<p>CLAYTON COUNTY Water AUTHORITY</p> <p>1600 Battle Creek Road, Morrow, GA 30260</p>	Jesters Creek East Outfall Replacement – Phase 2	
	ADDENDUM #1	
	DATE	Wednesday, December 29, 2021
	BID NUMBER	2021-PME-22
	BID OPENING DATE	January 6, 2022, at 2:00 pm
ADDENDUM MUST BE SIGNED AND INCLUDED IN YOUR RESPONSE TO THE RFB.

**JESTERS CREEK EAST OUTFALL
REPLACEMENT – PHASE 2**

CONSTRUCTION PLAN FOR JESTERS CREEK EAST OUTFALL REPLACEMENT PHASE TWO FOR BID

LARGE DIAMETER MANHOLE SECTION
N.T.S.

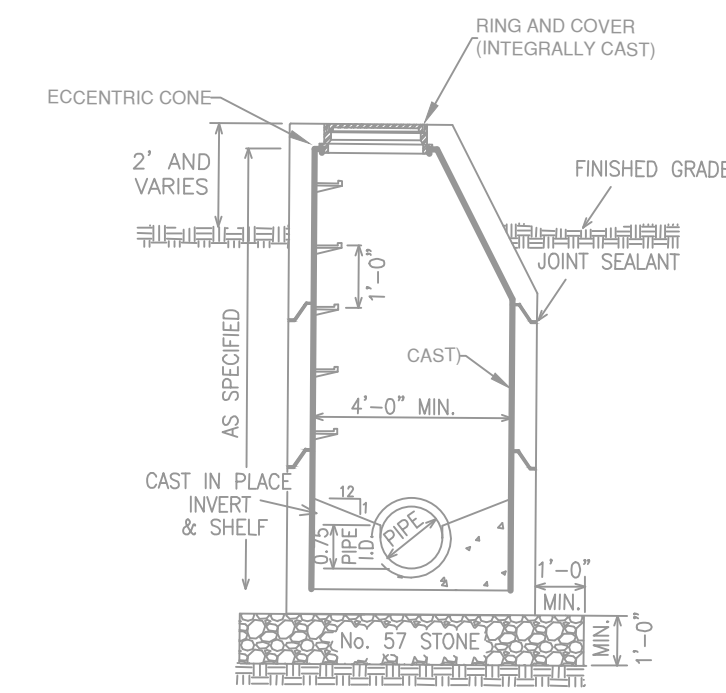
- 18. Drawing #P-9 Large Diameter Manhole Section Detail shows invert poured to 0.075 Pipe ID. Please confirm that this is 0.75 Pipe ID.**

The invert is poured to 0.75 Pipe ID. The Section Detail has been revised.

DATE:	NO.:	REQUESTED BY:	DESCRIPTION:
12-20-21	3	KW	VERIFY 98% MAX DRY DENSITY IN NOTES
12-20-21	4	KW	VERIFY INVERT POURED TO 0.75ID ON DETAIL

TYPICAL SANITARY SEWER PIPE BEDDING
N.T.S.

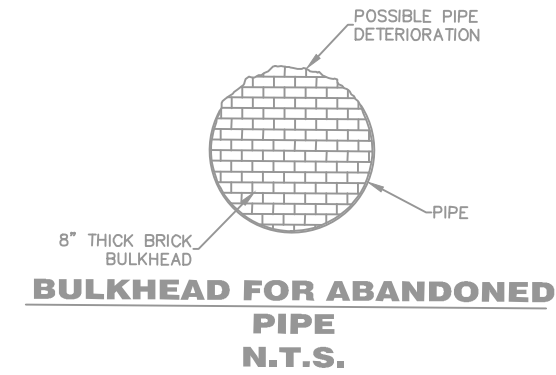
14. Specifications Page 4-3.29, 3.8.1.C indicates stone bedding to a height 6” above the top of the pipe, whereas Drawing #P-9, Typical Sanitary Sewer Pipe Bedding Detail indicates stone bedding to a height 1’ above the top of the pipe. Please clarify.

Revision was made indicating the height of stone to be installed above the pipe. Revision is highlighted in yellow.

Pipe bedding stone shall be installed as indicated on the Pipe Bedding Detail. Division 4, Section 3.8.1, Item C has been revised to indicate 12 inches.
